**Overview:** Production error; immobilizer wire (orange/black) in pin position #4 instead of pin position #5. Although an effort to correct the issue was made, some quantity of harnesses did get shipped before the issue was spotted. We are advising to inspect the harness BLADE connector before attempting to install the harness and program the module.

**Descripción general:** El nuevo arnés en T FTI-STP1 requiere modificaciones para su uso en aplicaciones de transmisión automática (AT).

## FTI-STP1: Notas de instalación y configuración

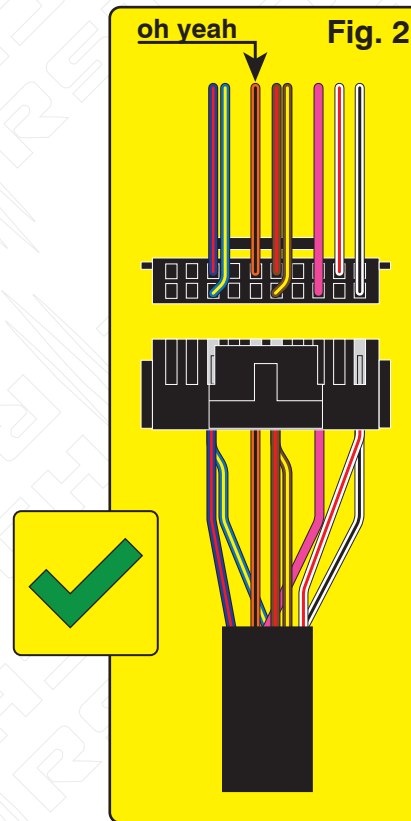
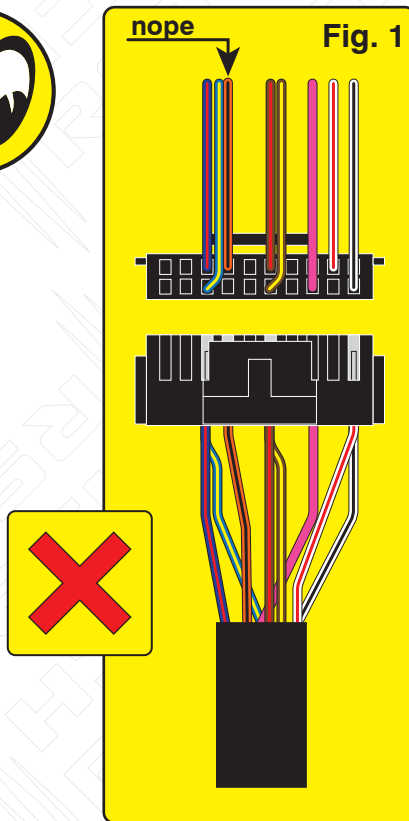
**Issue:** Module fails to program to vehicle, will not allow the vehicle to be remote started.

**Correction:** Step 1.) Locate the orange/black wire and confirm whether it is positioned as illustrated in Fig. 1 or Fig. 2. If the wire is as illustrated in Fig.1, proceed with Step 2 through 5 and complete the repair procedure outlined, if the wire is as illustrated in Fig. 2, correction is not necessary, proceed with harness installation and module programming.

**Step 2.)** Using a pick, lightly depress the catch that secures the terminal in the housing then remove the wire and terminal from the housing.

**Step 3.)** Using a fine tip razor or utility knife, insert the blade beneath the terminal catch and raise it slightly, so that it can be reused to secure the terminal when reinserted into the BLADE connector housing.

**Step 4.)** Refer to Fig. 2 for correct position of the orange/black wire (next to brown/red) then reinsert the terminal, pressing lightly until the catch 'snaps' into place, securing the terminal in the connector housing.

**Step 5.)** The repair is complete, proceed with installation and programming.

**MODIFICACIÓN REQUERIDA PARA APLICACIONES DE TRANSMISIÓN AUTOMÁTICA ÚNICAMENTE**

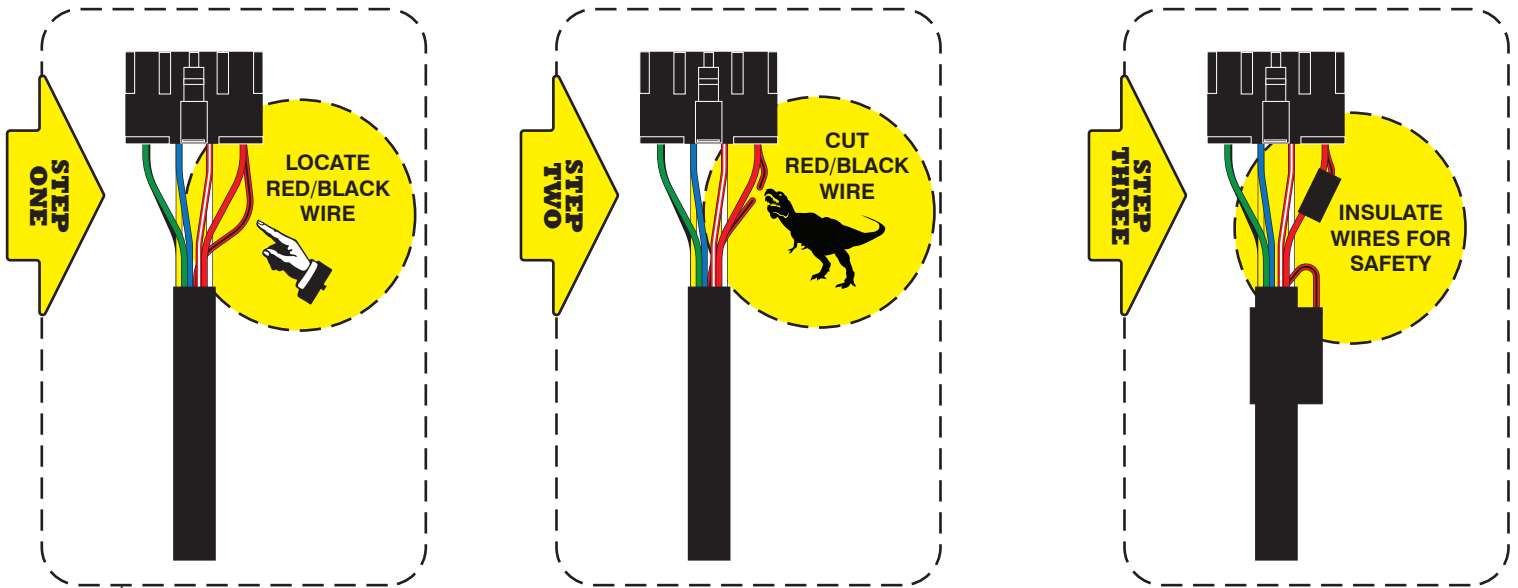
**Problema:** El arnés en T FTI-STP1 ha sido diseñado para ser compatible con AT (transmisión automática) y MT (transmisión manual), pero debido a una supervisión de la producción, el mecanismo de selección se estableció por defecto en el modo MT.

*El uso de un arnés configurado para una aplicación MT, en un vehículo equipado con AT, podría provocar daños en el módulo del vehículo. Se recomienda que el arnés vuelva al modo AT antes de instalarlo en vehículos equipados con transmisión automática.*

**Corrección:** Localice el cable rojo/negro (+ embrague) provisto en el conector CN1 del conjunto del arnés principal. Corte el cable rojo / negro, ya sea al ras del conector CN1 o dejando suficiente cable expuesto para que pueda aislar y asegure los extremos del alambre que quedan después del corte. Aísle cada uno de los extremos restantes del cable rojo/negro y asegúrelos para evitar cualquier posibilidad de cortocircuito.
